**21 Bedford Square**

**2015/4180/P and 2015/5032/L**

<b>Delegated Report (Members Briefing)</b>		<b>Analysis sheet</b>	<b>Expiry Date:</b>	<b>17/09/2015</b>
		N/A	<b>Consultation Expiry Date:</b>	29/09/2015
<b>Officer</b>			<b>Application Number(s)</b>	
Jennifer Chivers			1. 2015/4180/P 2. 2015/5032/L	
<b>Application Address</b>			<b>Drawing Numbers</b>	
21 Bedford Square London WC1B 3HH			Refer to Draft Decision Notices	
<b>PO 3/4</b>	<b>Area Team Signature</b>	<b>C&amp;UD</b>	<b>Authorised Officer Signature</b>	
<b>Proposal(s)</b>

Photograph One: Front Façade of Bedford Square

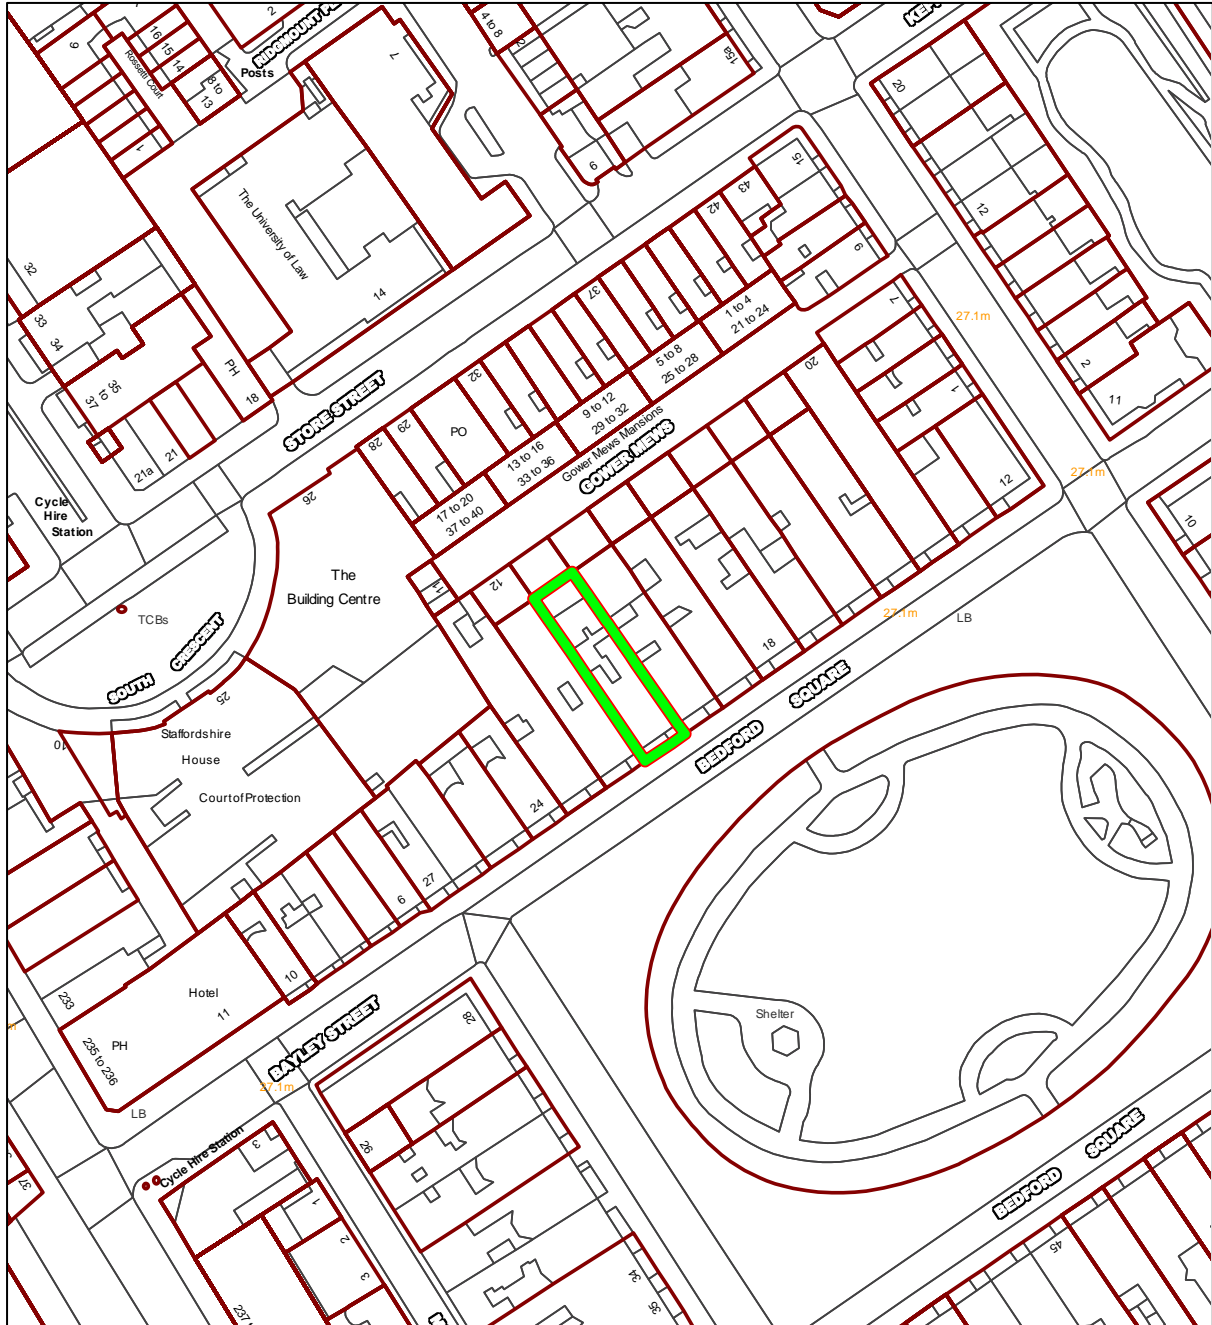
- 1.4 It is also proposed to dismantle and rebuild the front chimney stack located on the party wall between 21 and 22 Bedford Square (to the west) and the chimney located on the coach house. The chimneys are currently leaning considerably (as viewed in photograph one attached).

- 3.5 Externally, it is proposed to dismantle and rebuild the chimneystack to the west; this is considered to be acceptable as it is in an unsafe condition and strapping will not solve the instability issue. There will be no loss of historic fabric involved in this part of the proposal
